2021.4234.P 43A Redington Road

Delegated Report (Members Briefing)		A	Analysis sheet		Expiry Date:	27/10/2021		
		N	I/A		Consultation Expiry Date:	14/11/2021		
Officer				Application N				
Obote Hope				2021/4234/P				
Application	Address			Drawing Numbers				
43 A Redington Road London NW3 7RA			See draft decision notice					
PO 3/4	Area Tea	m Signature	C&UD	Authorised O	fficer Signature			
Proposal(s)								
basement le	evel for a tw	o storey side	infill extensior		ground floor leven and ground floor, om.			
Recommendation(s): Grant conditional planning permission

Erection of a single storey rear extension with terrace at upper-ground floor level, excavation at basement level for a two storey side infill extension at basement and ground floor, landscaping and levels alterations and the conversion of the garage to a habitable room.

Image 8. Showing the proposed landscaping details.

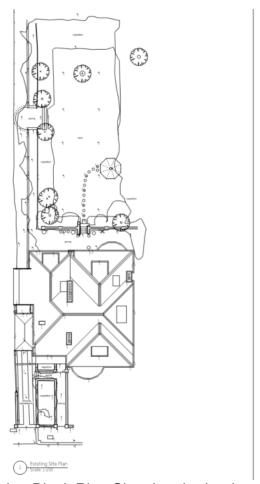
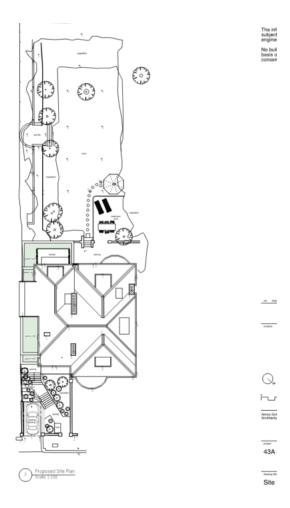
1.4 The original submission resulted in changes to the landscaping treatment to the front elevation, the loss of the rear ground floor window and the original door at lower-ground and ground floor level. The revised soft landscaping treatment would result in additional hardstanding being removed with enhance planters. Regarding the extension to the front and rear elevations the materials proposed would have failed to preserve or enhance the character of the host building and the wider area. Following negotiation with officers, a revised submission was provided which included the mitigation set out above.

Image 1. Existing front garden treatment

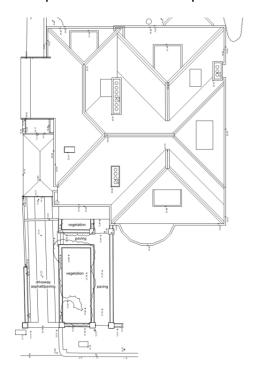
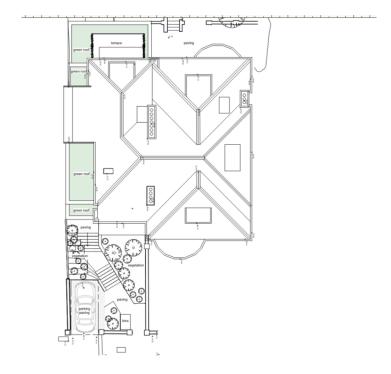
4.1 The proposed extension and new hard and soft landscaping would not result in the loss of any existing trees. The existing front garden treatment consist of asphalt paving and vegetation, it is proposed to install paving stones as a replacement to the asphalt, introduce new vegetation along the sides and the front of the existing car parking space. The associated landscaping proposed incorporates additional planting and this would enhance the character of the area offering more biodiversity whilst enhancing the verdant character of the area. Overall, the works comply with the Neighbourhood Plan policies BG1 and SD1 that relate to garden land development. Upon consultation with the Tree Officer conditions are recommended to require

4.2 New stepped accesses would be created to the front elevation and the existing paved area would provide access from the garden into the proposed basement. The design of the proposed external staircase arrangement, by way of their locations and planter screening would not be prominent. However, to ensure that this would be the case, a condition would be attached for the details of the hard and soft landscaping to be submitted and approve.

9 No development shall take place until full details of hard and soft landscaping and means of enclosure of all un-built, open areas have been submitted to and approved by the local planning authority in writing. [Such details shall include details of any proposed earthworks including grading, mounding and other changes in ground levels.] The relevant part of the works shall not be carried out otherwise than in accordance with the details thus approved.
